TRANS/WP.29/GRE/2002/35
17 July 2002

World Forum for Harmonization of Vehicle Regulations (WP.29)

PROPOSAL FOR COLLECTIVE AMENDMENTS TO
REGULATIONS Nos. 6, 7, 23, 38, 50, 77 and 91

Transmitted by the Expert from the Working Party "Brussels 1952" (GTB)

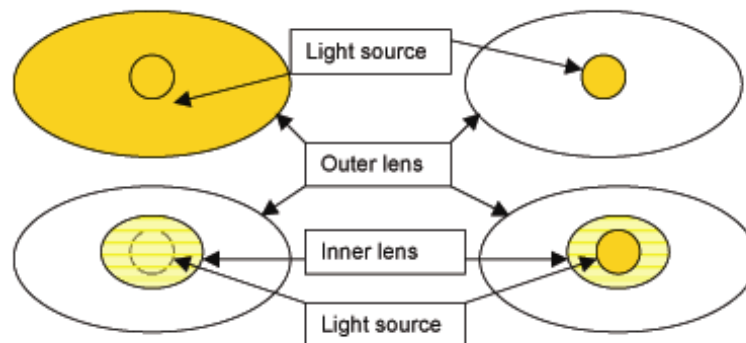
B.1- Problem description

Example:

A side direction indicator with two variations:

- Amber outer lens with W5W filament lamp
- clear outer lens with WY5W filament lamp
- clear outer lens with W5W filament lamp having an internal amber lens
- amber outer lens with W5W filament lamp having an internal clear lens

The amber and clear outer lenses have identical optical characteristics. These lamps need different type approval numbers.
